## Detailed Site Plan Bruster's Real Ice Cream

## DSP-18043

SUBJECT: Detailed Site Plan DSP-18043  
Bruster's Real Ice Cream

# SITE PLAN

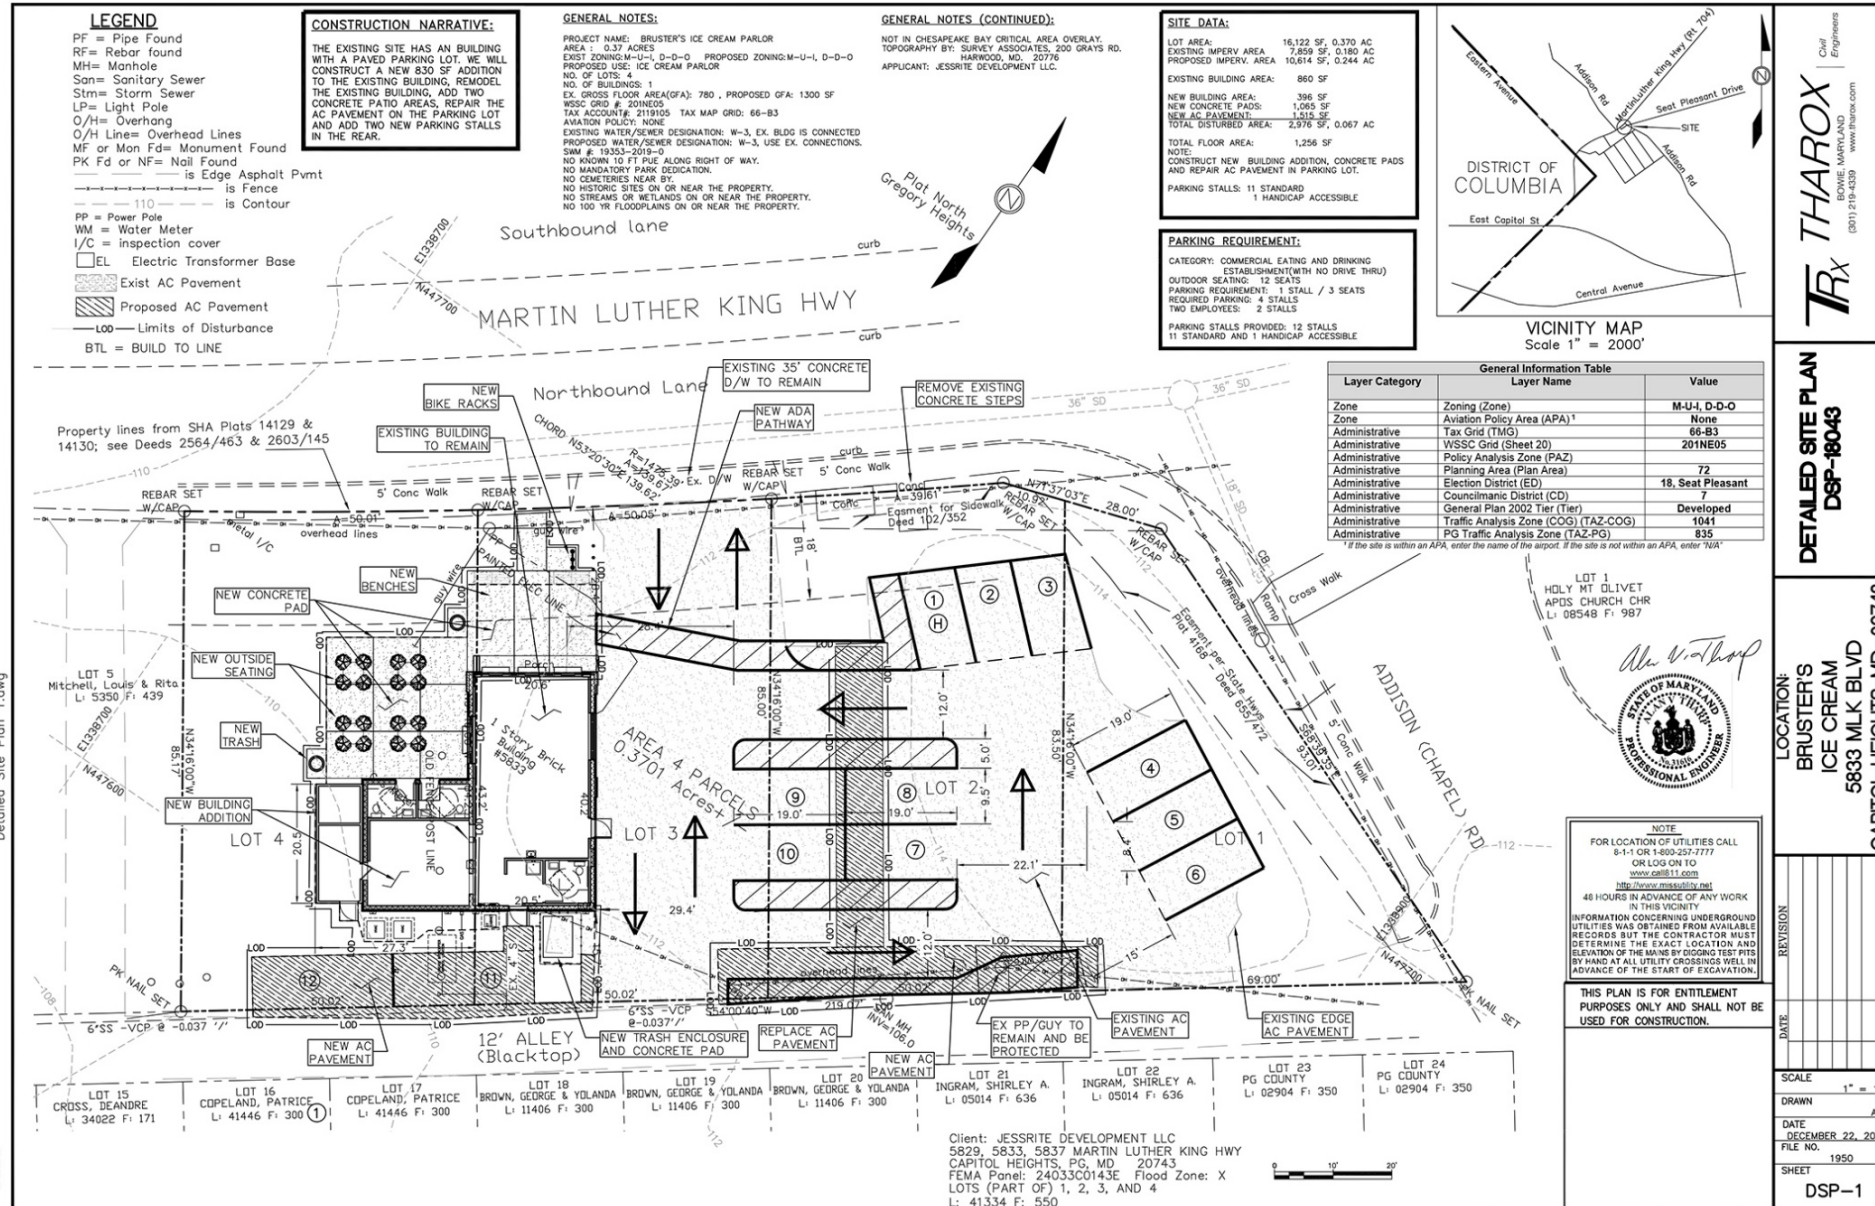
**Lighting**—This DSP is proposing an addition to an existing building that predates the D-D-O Zone, and the existing building does not have exterior lighting. This site plan does not propose lighting and should be revised to provide lighting to illuminate the building and parking areas on the site, as required. The proposed lighting should provide a balanced lighting pattern on the property, highlighting the building entrances and providing patrons with a bright, safe atmosphere while not causing a glare onto adjoining properties. A condition has been included in the Recommendation section of this report, requiring that the site plan be revised to include sufficient lighting.

The master plan rights-of-way for A-22 (MD 704) and C-408 (Addison Road) are not labeled on the submitted plan. The subject property currently has three vehicle entry points, one of which is on MD 704 and the remaining two on the alley which fronts the subject property to the south. This project proposes to remove the one vehicle access from alley. The remaining two points of vehicle entry will be used as an entrance or exit.

- b. Provide a continental style crosswalk traversing the driveway along MD 704 unless modified by the Maryland State Highway Administration with written correspondence.

- c. Shift the existing crosswalk traversing Addison Road north to the intersection of MD 704 and Addison Road.
    - d. Provide a detailed exhibit of the inverted-U style bicycle rack or racks of a similar style that provide two points of contact for securing and supporting each parked bicycle.

- e. Show the ultimate planned right-of-way for master plan road A-22 (MD 704), which is a planned 120-foot arterial road along the property frontage, and master plan road C-408 (Addison Road), which is a planned 80-foot collector road along the property frontage.

1. The DSP should label the widths of ultimate right-of-way for master plan road A-22 (Martin Luther King Jr. Highway) which is a planned 120-foot arterial road along the property frontage; and master plan road C-408 (Addison Road) which is a planned 80-foot collector

2. The DSP labels existing properties as Lots 1, 2, 3, and 4, whereas these properties no longer conform to the boundaries of these lots as originally platted after conveyance of public rights-of-way. The existing properties should be labeled as per the property survey and reference added to the record plat, for example, "Part of Lot 1, Plat Book 5-84".

The master plan rights-of-way for A-22 (Martin Luther King Jr. Highway) and C-408 (Addison Road) are not labeled on the submitted plan.

1. Floor plan shows 16 outdoor seats, but parking schedule lists 12. Revise parking schedule or architectural floor plan to match. If there are 16 outdoor seats, then the parking schedule needs to reflect the revised number of required spaces.

2. A spot dimension (length and width) of one space should be provided for each noncontiguous parking bay. Applicant has 4 bays. 3 do not provide a spot dimension.

4. Show build to line on site & landscape plan.
5. Show public R/W line on plans and identify the dooryard.
6. Identify frontage occupancy on plan to demonstrate conformance to the general site guidelines.

7. Show dimension of HC space, access aisle and ADA pathway.
8. Show building height, square footage and dimensions, labeling the existing structure as "Existing", the proposed addition as "Proposed Addition" and the proposed cooler as "Proposed Cooler".

1. Prior to certificate approval, the following revisions shall be made to the DSP:
  - a. Label the ultimate master plan right-of-way widths for Martin Luther King Jr. Highway and Addison Road.
  - b. Revise labels for existing properties in accordance with the property survey and add reference to Plat Book 5-84.

1. Prior to certification of the detailed site plan, the applicant, or the applicant's heirs, successors, and/or assigns shall revise the plans to provide:

- a. Continental style crosswalk crossing the driveway along Martin Luther King Jr. Highway unless modified by the Maryland State Highway Administration (SHA) with written correspondence.

- b. Existing crosswalk crossing Addison Road be shifted north to the intersection of Martin Luther King Jr. Highway and Addison Road
  - c. A detailed exhibit of the inverted-u style bicycle rack or racks of a similar style that provide two points of contact for securing and supporting each parked bicycle.

- d. Ultimate planned right-of-way for master plan road A-22 (Martin Luther King Jr. Highway) which is a planned 120-foot arterial road along the property frontage; and master plan road C-408 (Addison Road) which is a planned 80-foot collector road along the property frontage.
